1963 Corvette: Service Bulletin: Interim Production Changes

Subject: Interim Production Changes
Model and Year: 1963 Corvette
Source: Chevrolet Technical Service Bulletin
Bulletin No: DR #569
Section: XV
Date: December 31, 1962

PARKING BRAKE LEVER ASSEMBLY REPLACEMENT

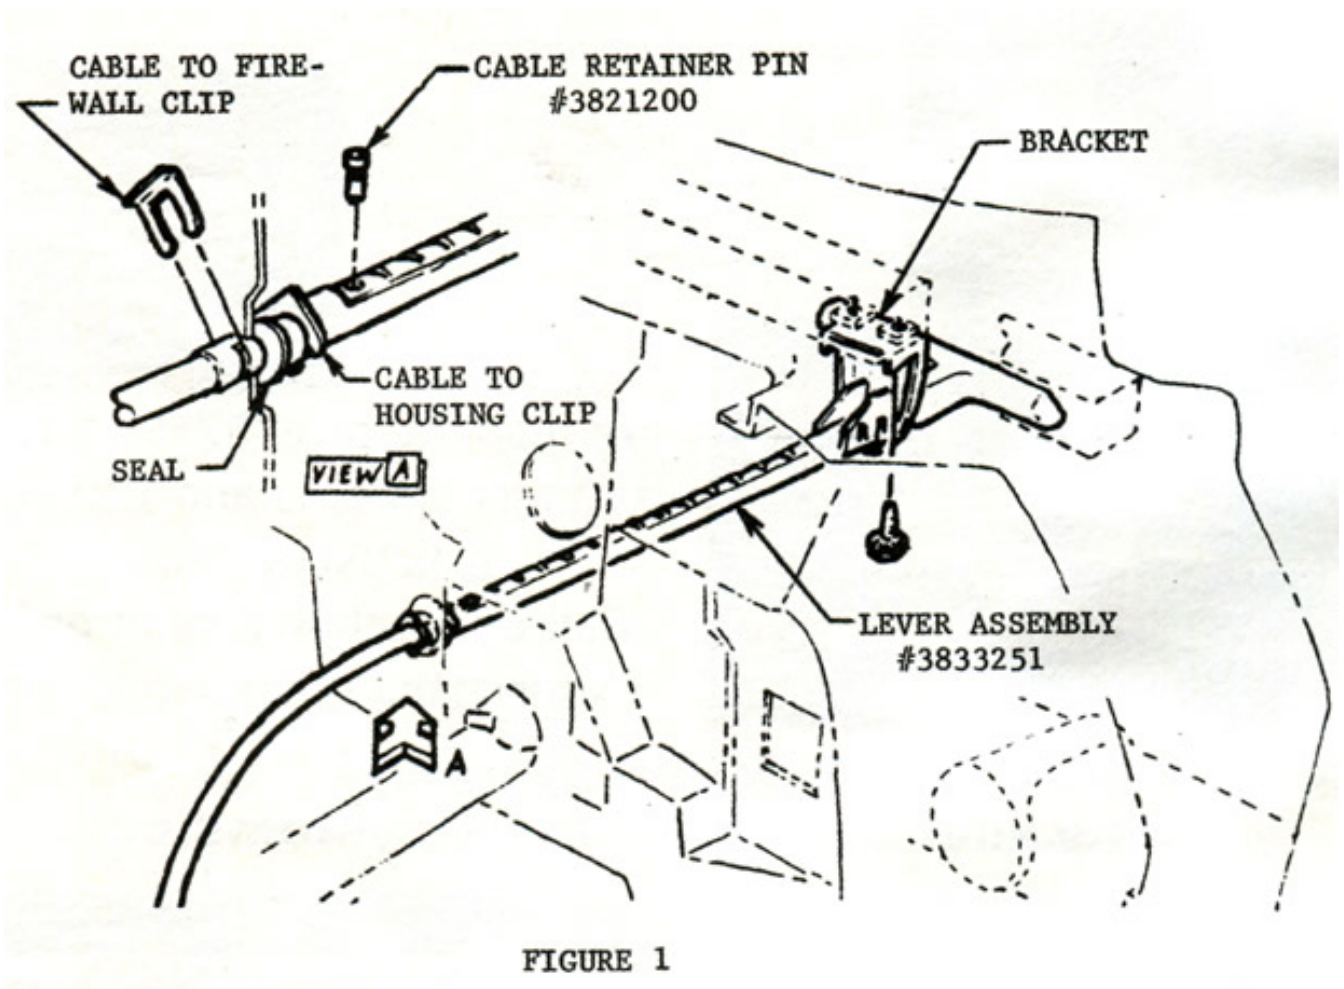
1. Effective with Serial No. S101893, a redesigned parking brake lever assembly entered Production. Early vehicles incorporate a lever assembly which may be difficult to release and in extreme cases, may actually jam making release impossible.
2. Vehicles with Serial No. S101847 through S102667, were built with a second design rear axle driveshaft flange that may not seat properly in the rear wheel drive spindle flange. An interference condition at this location could possibly lead to early failure of the rear wheel spindle flange attaching bolt bosses.

Lever Assembly should be replaced on all vehicles built prior to Serial No. S101893. Referring to Figure 1, proceed as follows:

1. Scrape sealer away from cable to firewall clip and remove clip.
2. Disconnect parking brake cable clip from steering gear retainer bolt.
3. Disconnect oil pressure line at gauge and pull line out of parking brake lever assembly bracket.
4. Remove two (2) bolts holding bracket to dash brace.
5. Pull complete lever and cable assembly to the rear, far enough to remove parking brake signal switch.
6. With handle all the way in, cable retainer pin will line up with hole in bottom of housing allowing pin to be driven out from bottom with a punch.
7. Remove cable to housing clip and separate cable from housing.
8. Install original seal on new lever assembly No. 3833251.
9. Reassemble by reversing the above steps using new cable retainer pin No. 3821200. NOTE: Chamfered side of pin must face forward to

actuate the parking brake signal switch properly.

10. Apply body sealer around cable at firewall to prevent water leaks.

FIGURE 2

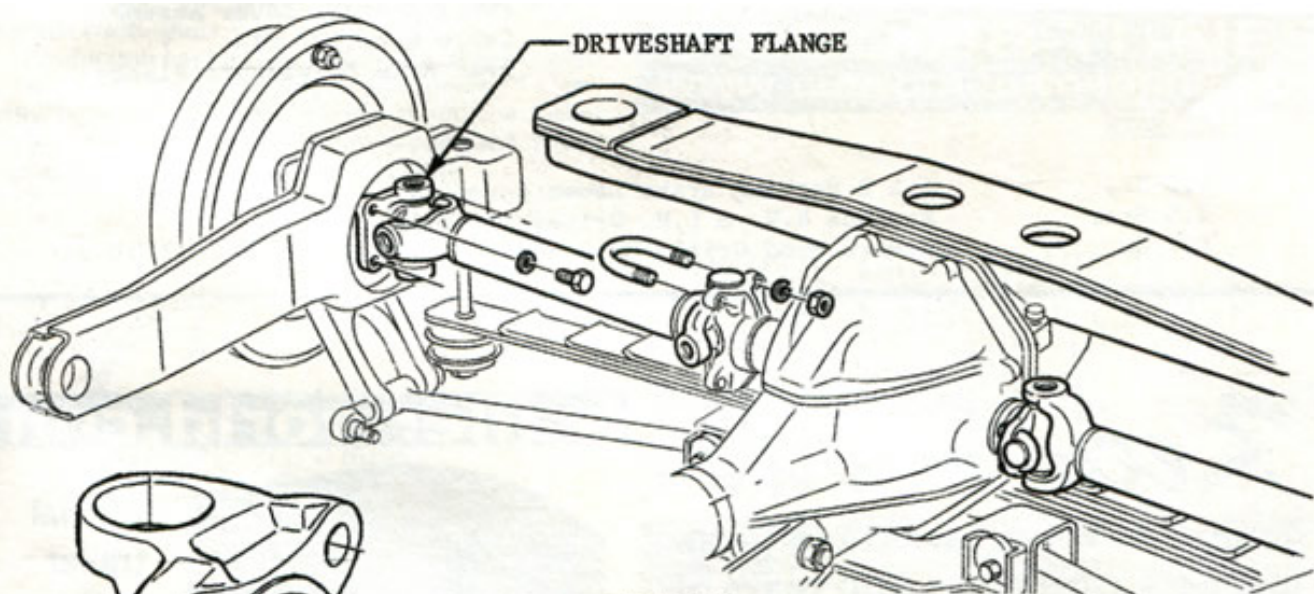
New machined Driveshaft Flanges No. 3832048, should be installed on all vehicles with Serial No. S101847 through S102667 (Ref. Figs. 2 and 3).

Replacement of the driveshaft flange is covered in the 1963 Corvette Shop Manual, Page 4-16. The rear wheel spindle flange attaching bolt bosses should be visually inspected while the axle driveshafts are out of the vehicle. Replace with new Spindle Flange Assembly No. 3830253 if any cracks are evident in the area indicated in Figure 4.

FIGURE 3 - DRIVESHAFT FLANGE

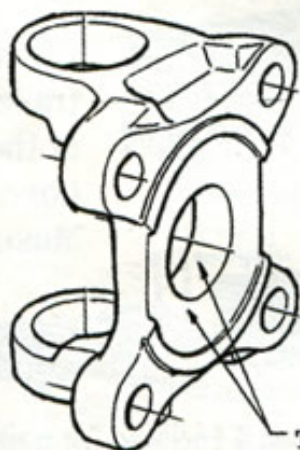
THESE SURFACES
MACHINED FOR
CLEARANCE

Vehicles built after S102667 incorporate selective fit pieces or additional machining to insure adequate clearance.

FIGURE 4 - SPINDLE FLANGE

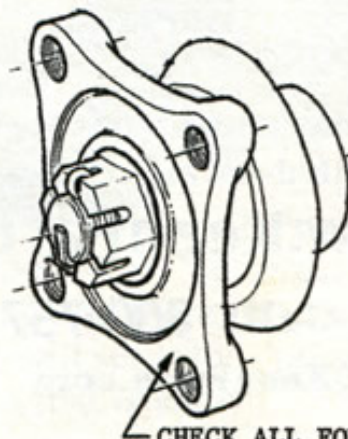
CHECK ALL FOUR
BOSSES FOR CRACKS
IN THIS AREA
